DESIGN REVIEW COMMITTEE

August 21, 2024 6:00 PM

**DEPARTMENT OF PLANNING AND ZONING
PLANNER'S REPORT**

RE: Design Review – 3293 Dogwood Drive

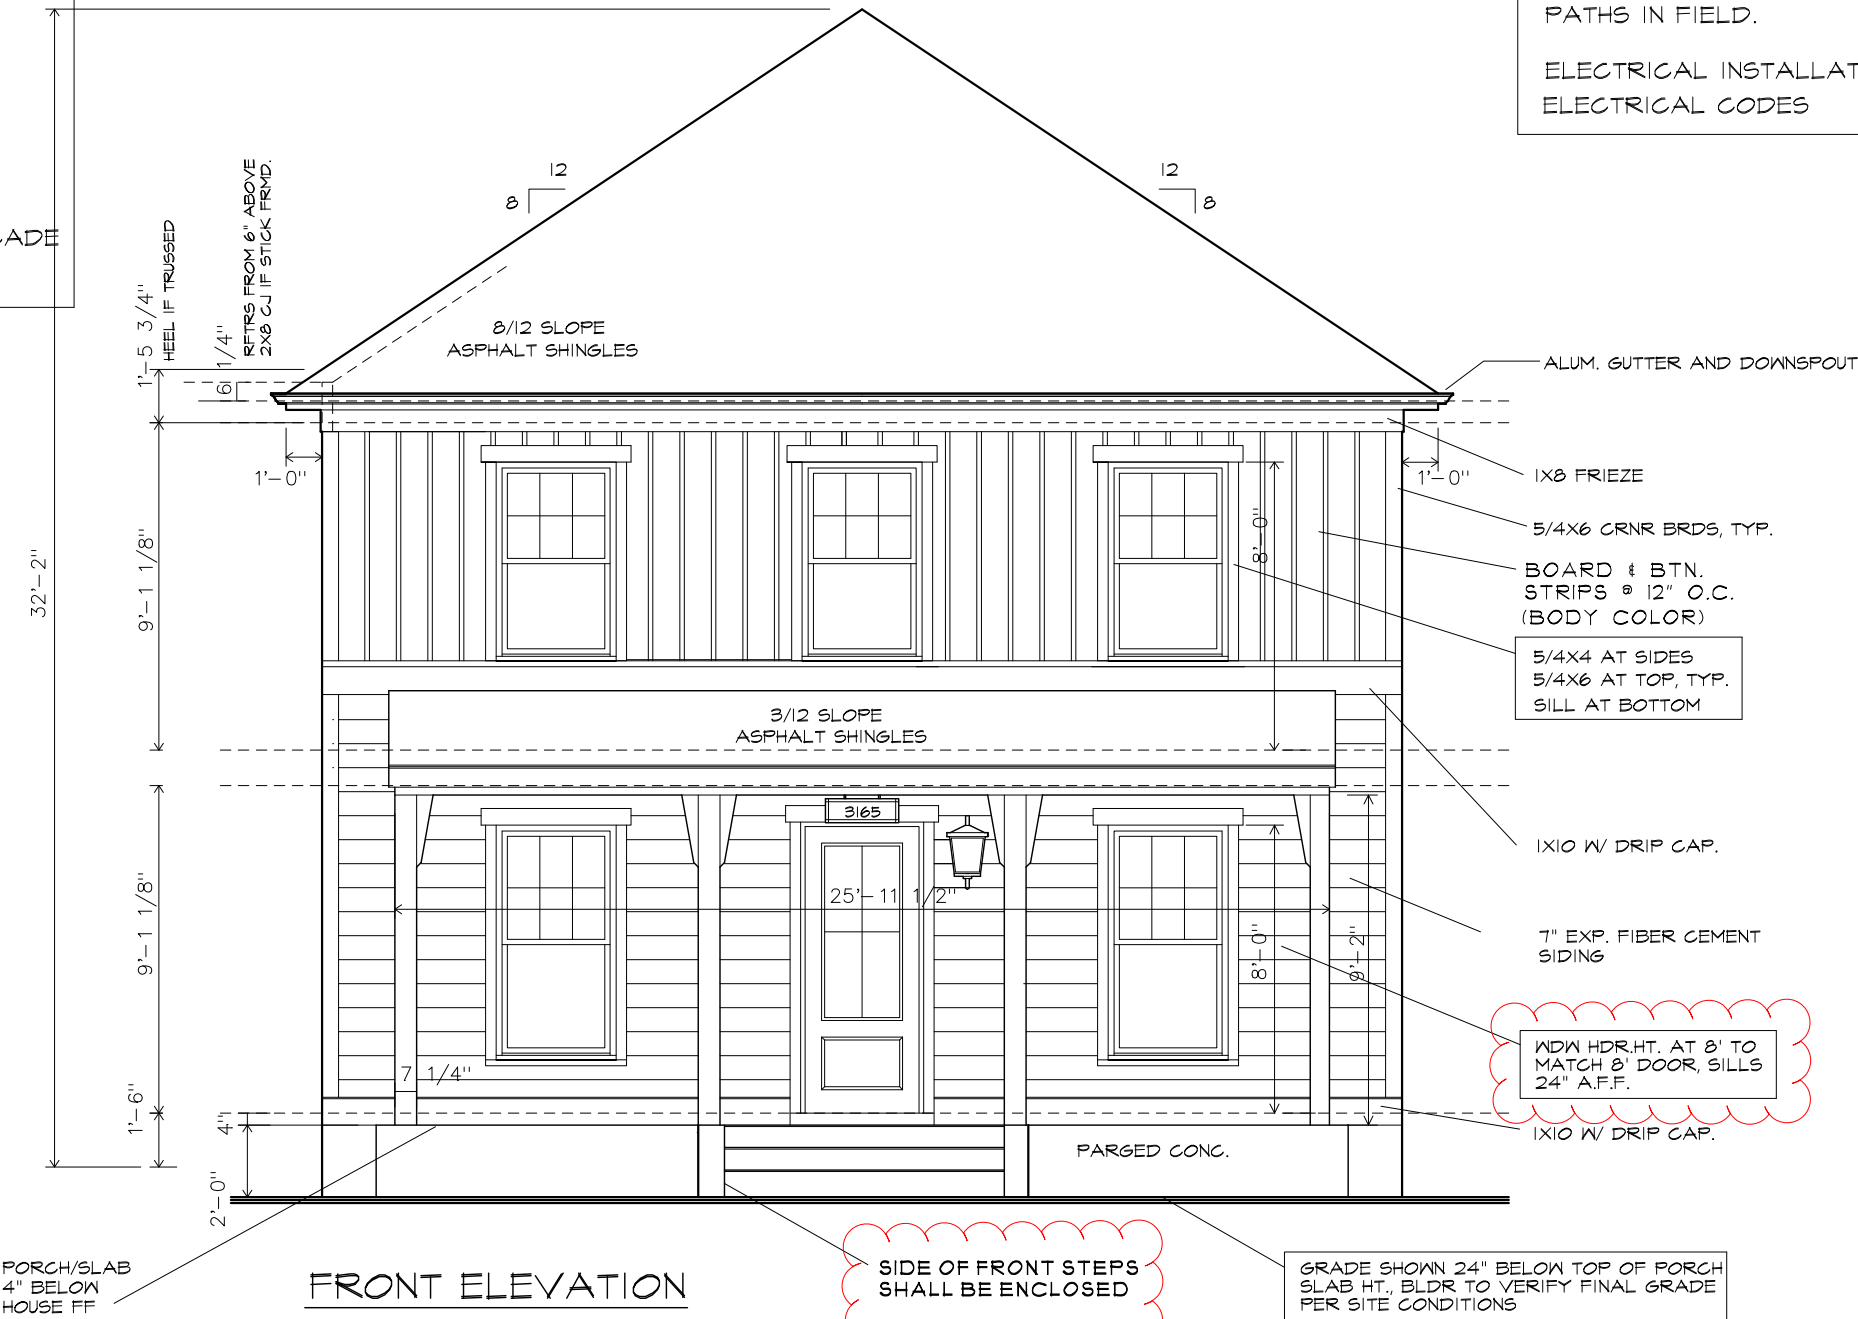
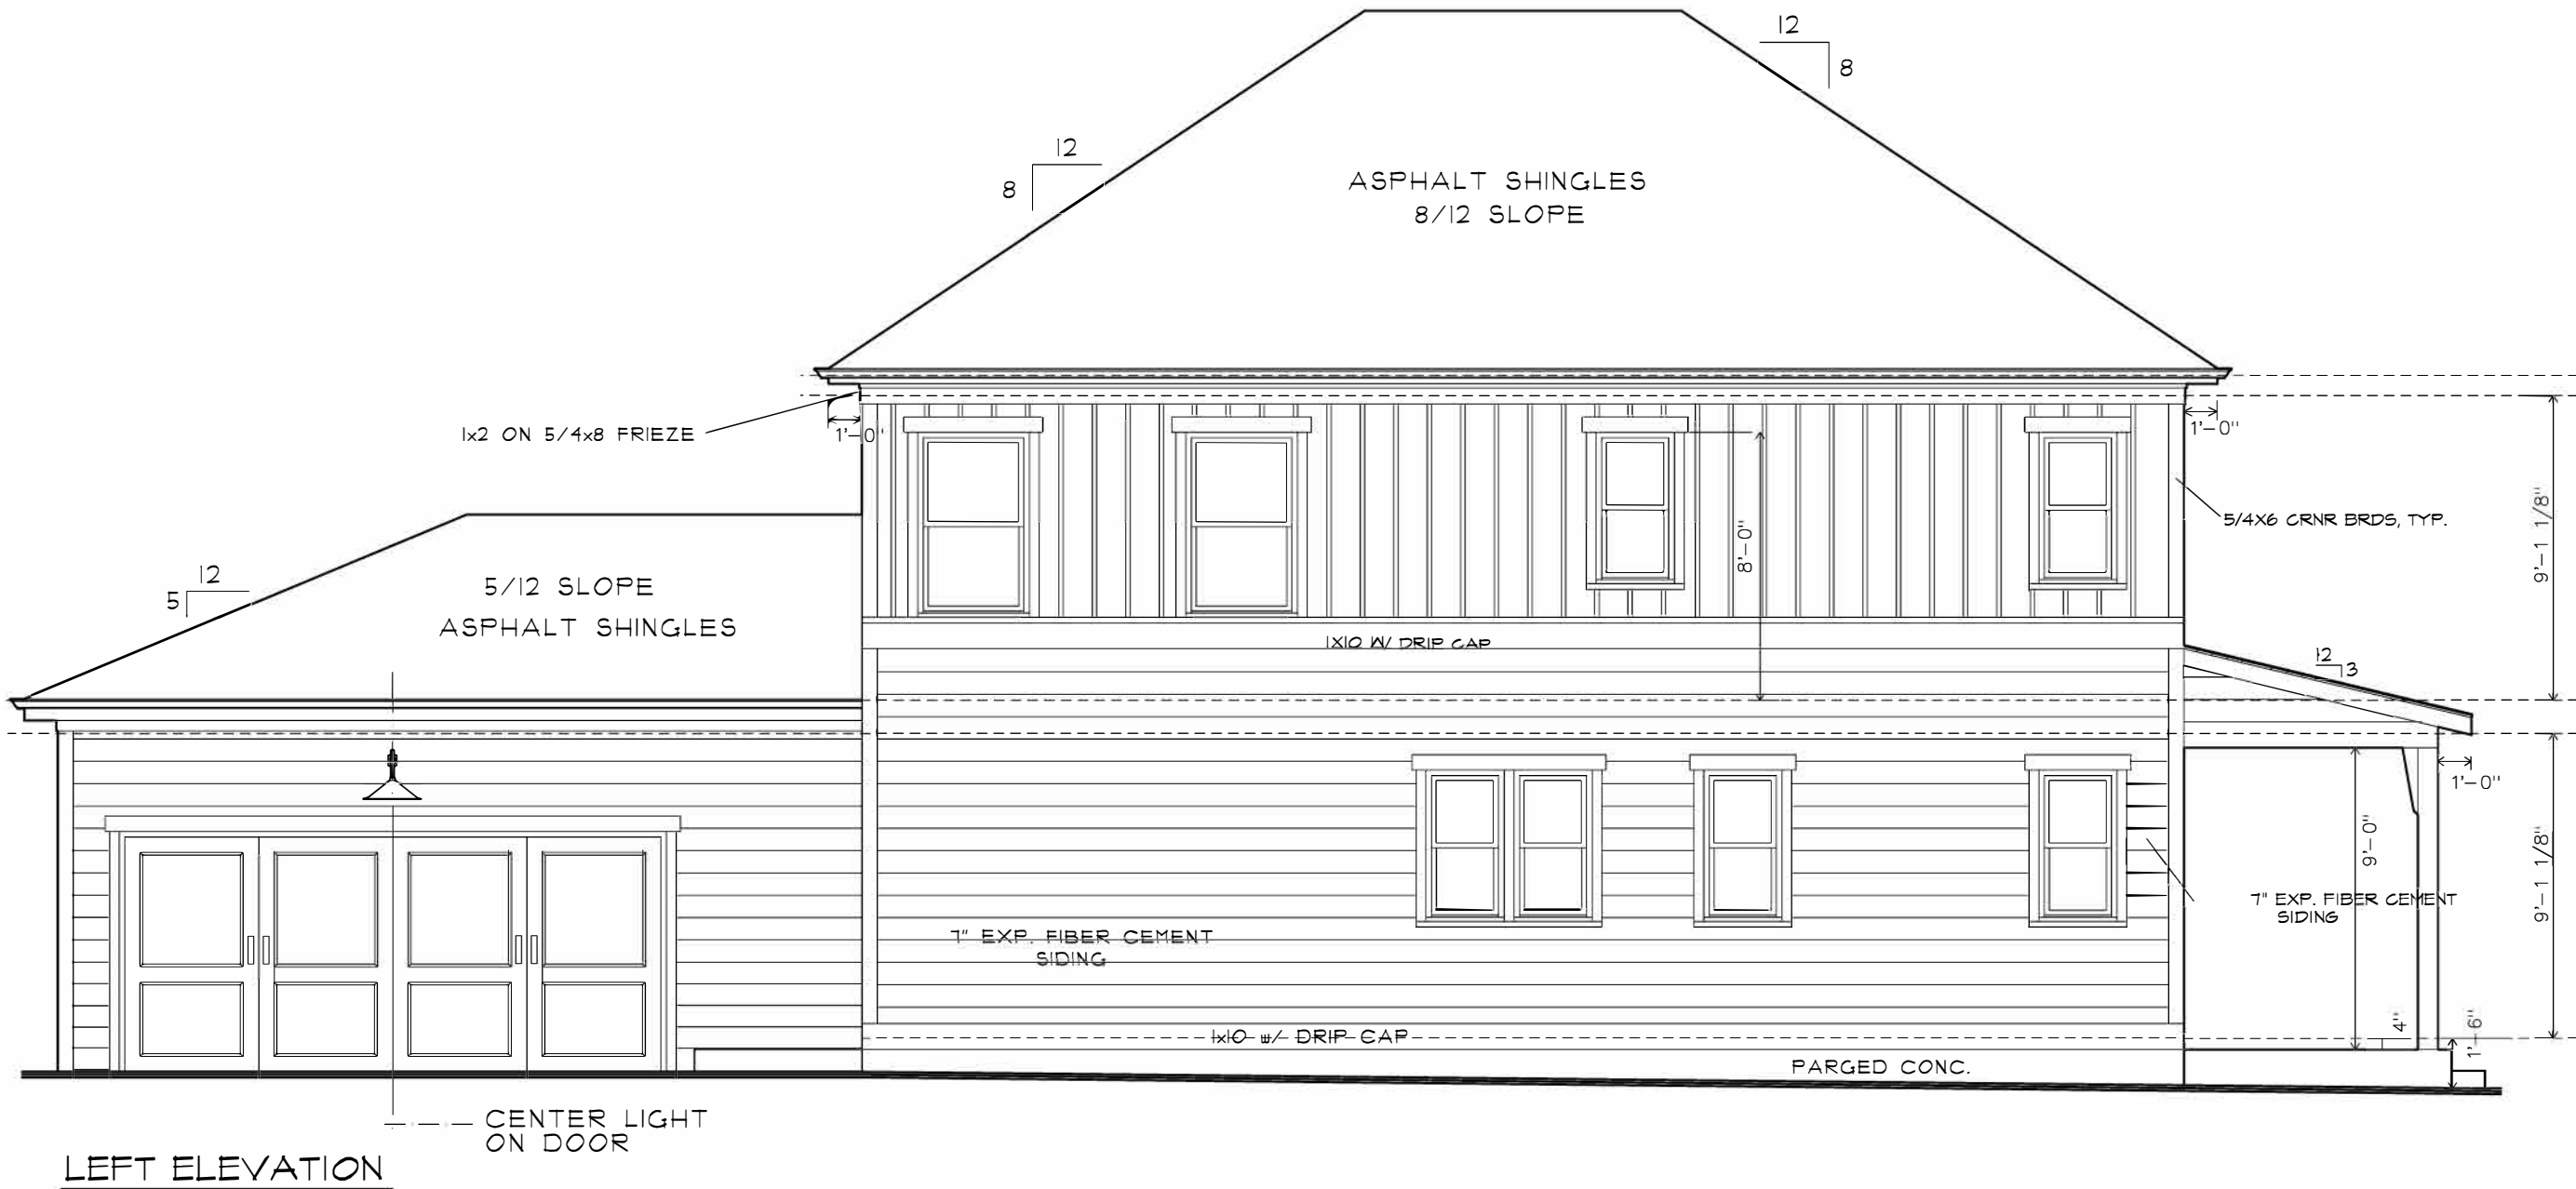
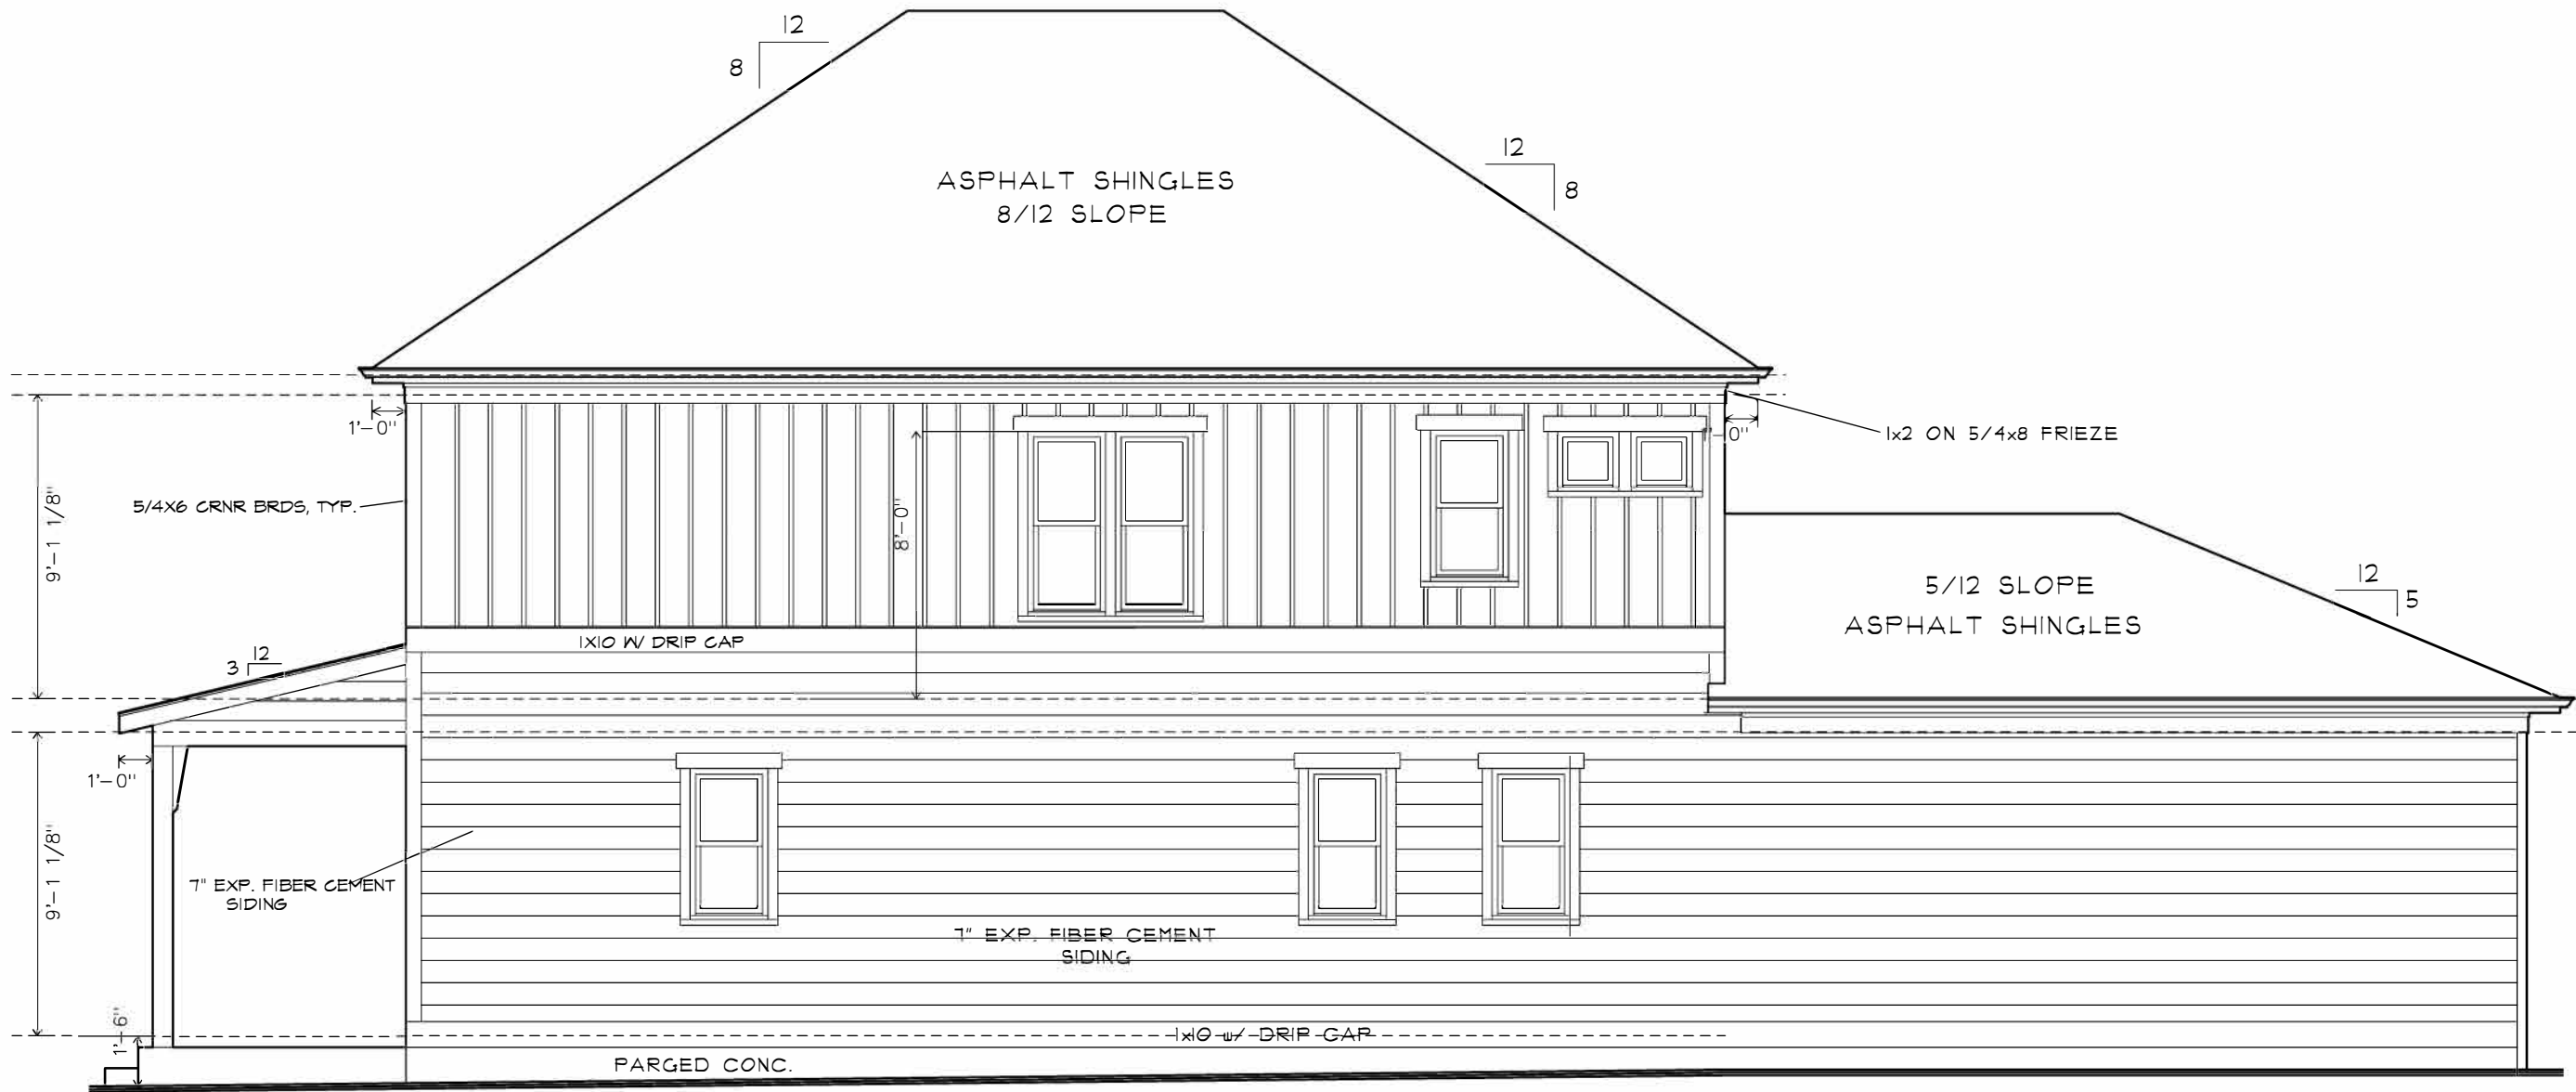
The City of Hapeville has received a revised design review application from Daniel Love of 3ELKS Design Ventures, for the installation of a dormer on the single family dwelling at 3085 Jackson Street. During construction, the contractor installed the dormer in error – it was approved for the adjacent lot.

Staff recommends approval of the modification. The dormer is consistent with Design Standards and had been approved on the adjacent property.
